**GPU Nuclear Corporation**  
Post Office Box 388  
Route 9 South  
Forked River, New Jersey 08731-0388  
609 971-4000  
Writer's Direct Dial Number:

September 2, 1994  
5000-94-0037  
C321-94-2022

Subject: Oyster Creek Nuclear Generating Station  
Docket No. 50-219  
Facility Operating License No. DPR-16  
Response to Request for Additional Information  
Re: Technical Specification Change Request No. 218  
dated May 12, 1994

APRM CHANNEL 2 & 7 COMBINED: FLOW INDUCED SCRAM SURVEILLANCE DATA

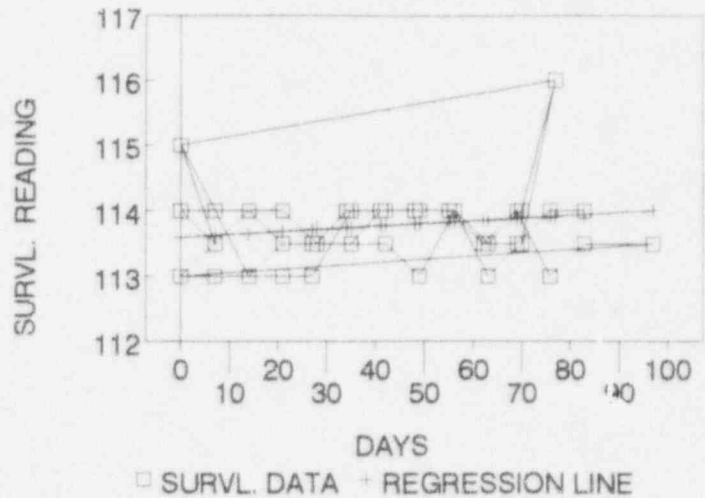
The setpoint for APRM scram channels 2 and 7 drifted outside the AS-FOUND acceptance criteria on three occasions (the Technical Specification limit was exceeded twice) over 25 surveillances for each channel, i.e., 3 times exceeding AS-FOUND acceptance criteria out of a total of 50 surveillances for these channels. The setpoints were adjusted to bring them within AS-LEFT criteria. Channels 2 and 7 are in different trip systems. Since all eight channels are identical in terms of hardware and function and as they share a common environment, four channels per trip system can be combined to determine a 95% Confidence Interval. As a simplified approach which provides conservative results, only the two channels whose setpoints were found outside

AS-FOUND acceptance criteria were analyzed using the regression model by combining the two sets of data in a single analysis (see Attachment 2). Accordingly, for the combined channels 2 and 7, the 95% Confidence Interval is as follows:

112.92 to 115.22% - This range exceeds the AS-FOUND criteria in the surveillance procedure but is well within the Technical Specification limit.

THE COMBINED CHANNELS DO NOT SATISFY THE "AS-FOUND" ACCEPTANCE CRITERIA BUT ARE NOT IN VIOLATION OF TECH SPEC LIMIT.
